2026-4619-ZC

ZONING STAFF REPORT
2026-4619-ZC

Requested Zoning: PBC (Planned Business Campus District), AML (Advanced Manufacturing and Logistics District), and RBCO (Regional Business Center Overlay District)

Street Landscape Buffer Area

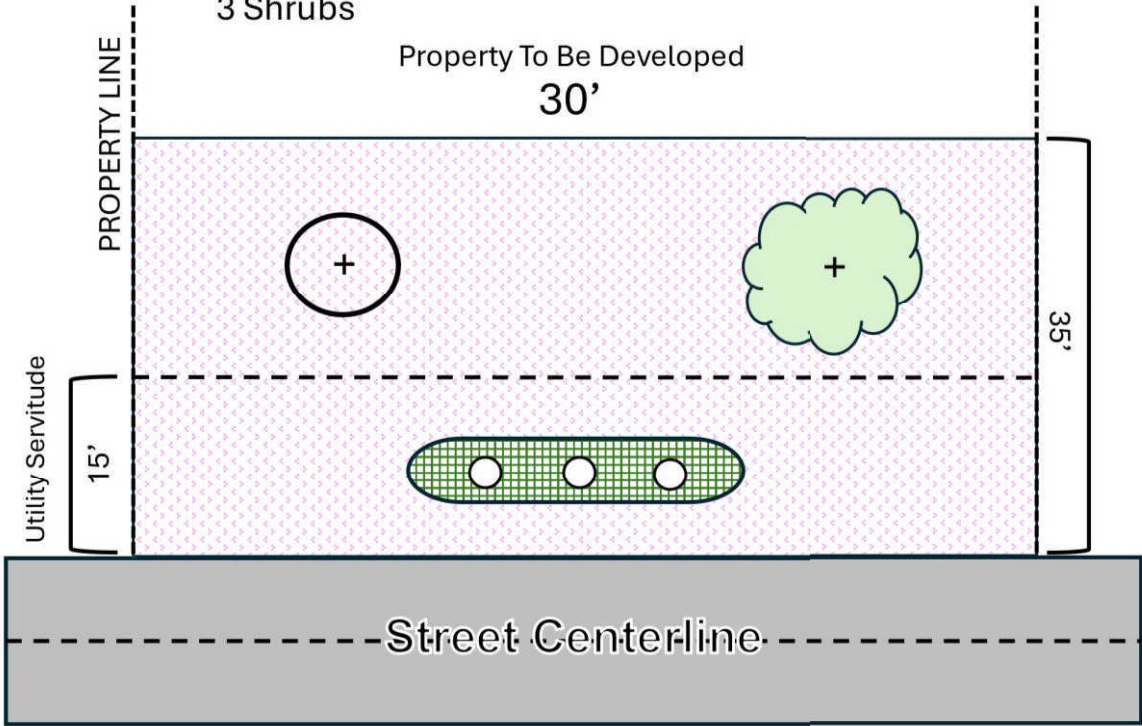
- Y. Street Landscape Buffer Area Chart: Requires 1 Class A tree, 1 Class B tree, and 3 shrubs

Staff Comment: The applicant should revise this to provide a maximum allowable percentage by which a single tree may count toward more than one landscape requirement and remove the verbiage "Mitigation Live Oaks Allowed". This picture should also be revised to reflect that the metric is 1 Class A tree, 1 Class B tree, and 3 shrubs per 100 linear feet, and not in general.
